Access Compliance Report

Public Rights-of-Way

(Curb Ramps)

Intersection ID: 14278	Main Street: ROMARE_BEARDEN_DR	Cross Street: FARMER_ST	Location: S
ADA ID: 092E7F409439	Ramp Type: MedianPerp	Initial Pass/Fail: Fail	Overall Compliance: No
Severity Score: 1.25			
Codes/Mitigation Info/Possible Solution		Field Measurements/Component Compliance

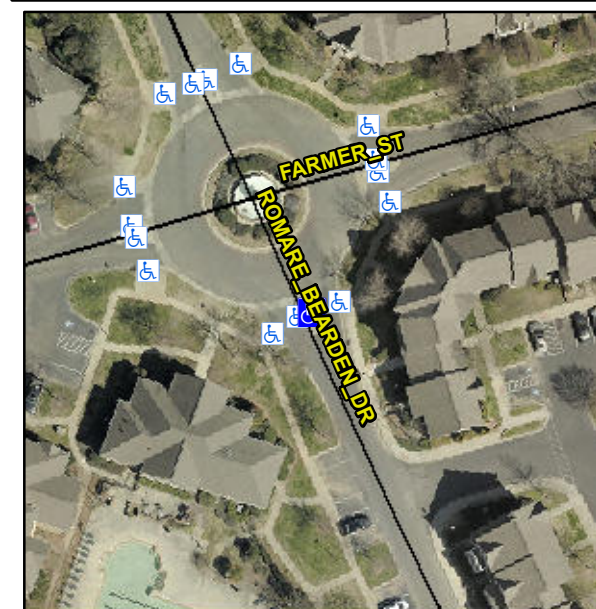
R304.5.3

Compliance	Description	Data	Compliance	Description	Data
N/A	Ramp Length (in)	43.0	Yes	Ramp Slope (%)	5.7
Yes	Ramp Width (in)	54.5	No	Ramp XSlope (%)	3.9
N/A	Flare Type LT	N/A	N/A	Flare Type RT	N/A
N/A	Flare Slope LT (%)	N/A	N/A	Flare Slope RT (%)	N/A
N/A	Flare Traversable LT?	N/A	N/A	Flare Traversable RT?	N/A
N/A	Landing Length (in)	N/A	N/A	DWS Provided?	N/A
N/A	Landing Width (in)	N/A	N/A	DWS Contrast?	N/A
N/A	Landing Slope (%)	N/A	N/A	DWS Length (in)	N/A
N/A	Landing X Slope (%)	N/A	N/A	DWS Full Width?	N/A
N/A	Landing Curb? (Y/N)	N/A	N/A	DWS Offset (in)	N/A
N/A	Shared Landing?	N/A			
N/A	Gutter Ponding?	N/A	N/A	Gutter Slope (%)	N/A
N/A	Gutter Lip Ht (in)	N/A	N/A	Gutter X Slope (%)	N/A
N/A	Painted X Walk1?	No	N/A	Painted X Walk2?	N/A
	X Walk 1 Direction	To E		X Walk 2 Direction	N/A
N/A	X Walk 1 Width (in)	N/A	N/A	X Walk 2 Width (in)	N/A
	X Walk 1 Slope (%)	0.1		X Walk 2 Slope (%)	N/A
	X Walk 1 X Slope (%)	2.2		X Walk 2 X Slope (%)	N/A

Remove & Replace Entire Ramp.
